Site / Mass Grading / Sediment Control Plans

Troy Hill Corporate Center

SDP-98-143

TROY HILL CORPORATE CENTER
 PHASE IIA
 TROY HILL DRIVE
 REVISED STORMWATER MANAGEMENT POND # 3

GABIION DITCH DETAIL
 NOT TO SCALE

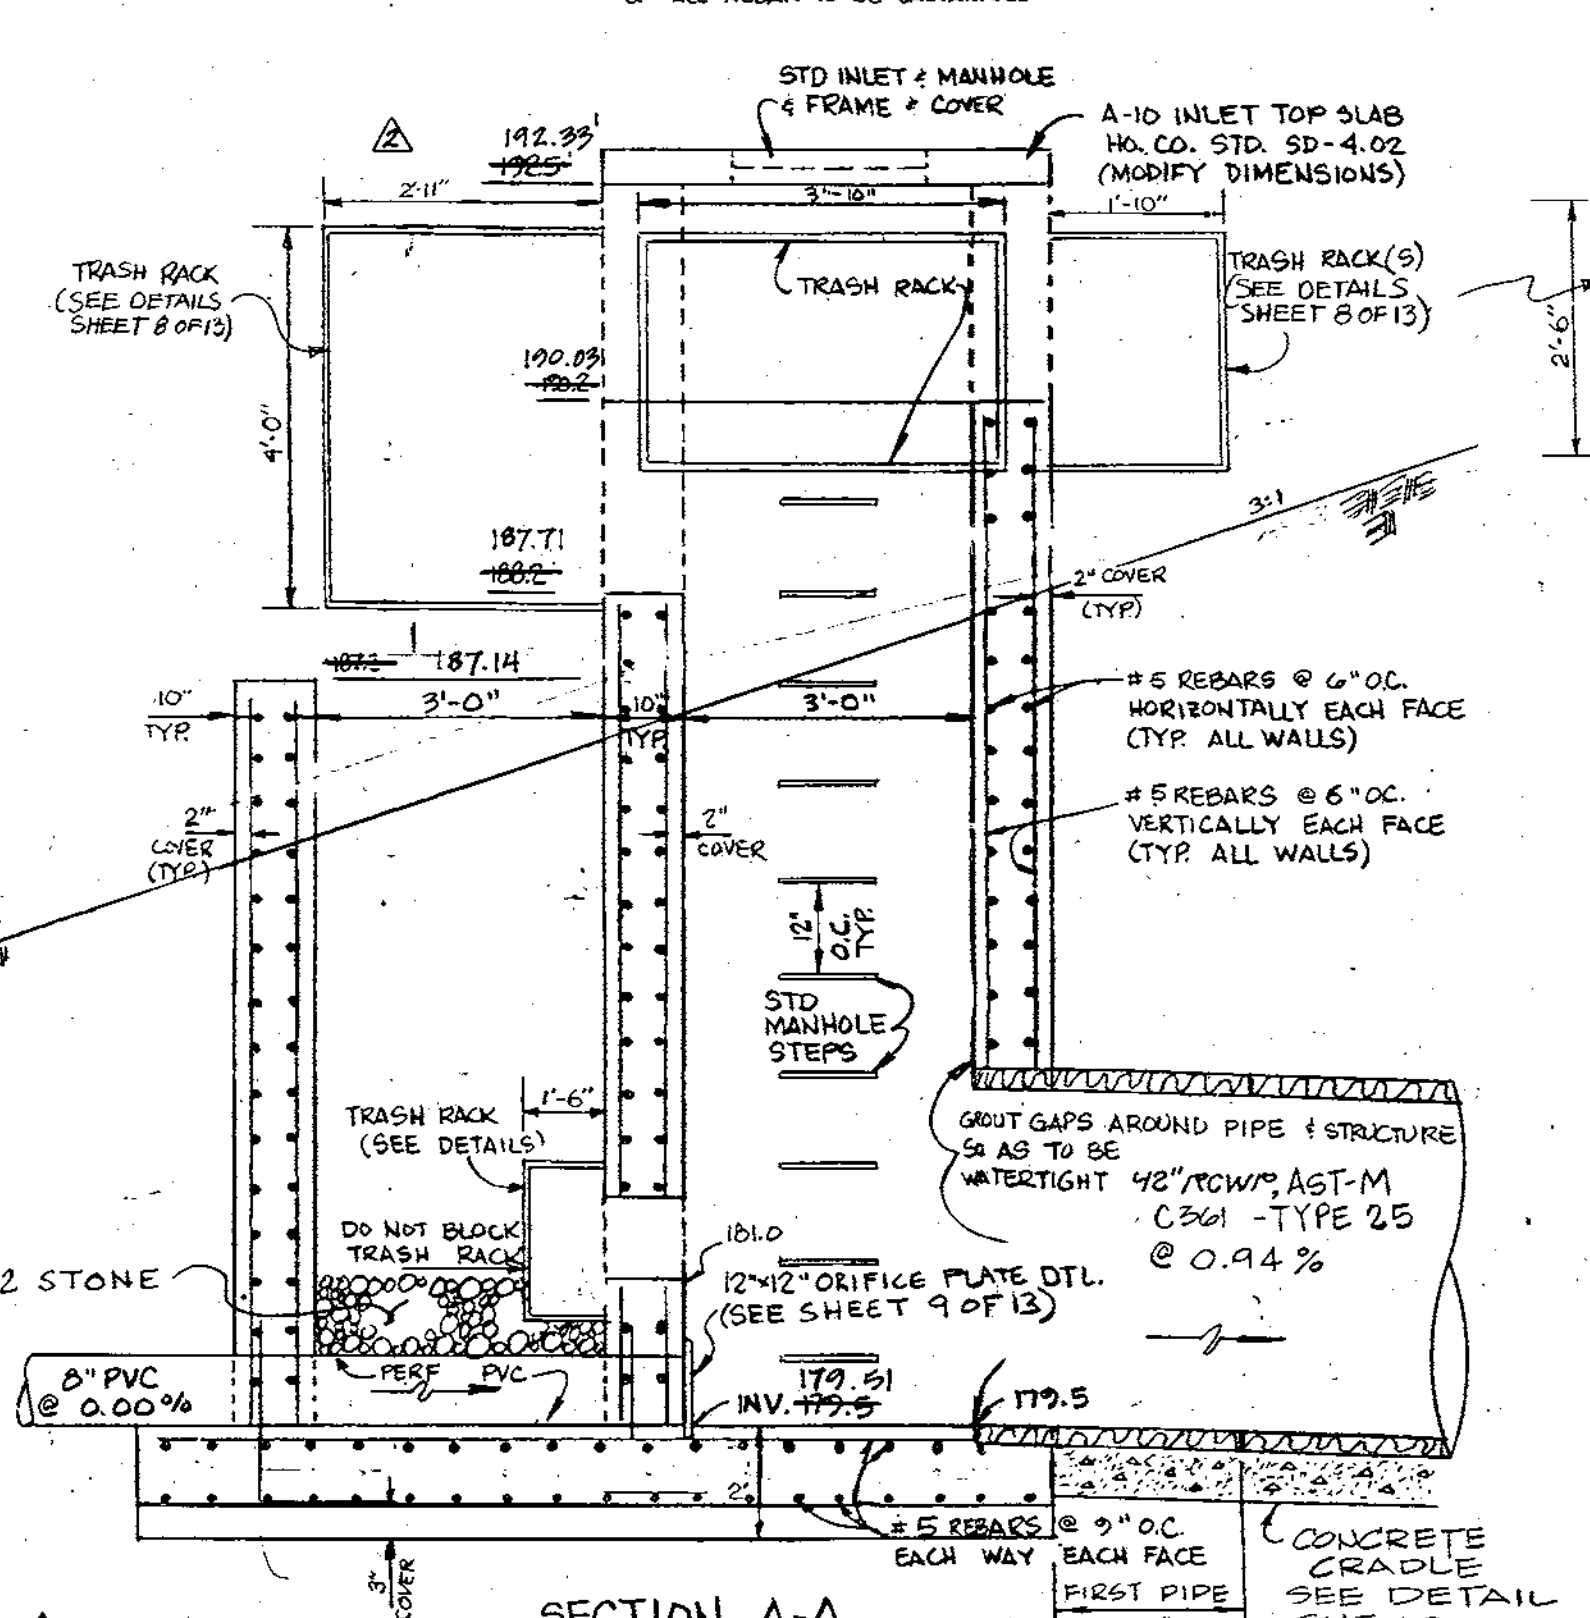
NO	REVISION	DATE
1	REVISE ACCESS RAMP GRAPES, MODIFY RISER, ELIMINATE LOW FLOW CHANNEL	11/09/98
2	Revise Riser Opening	11/20/98
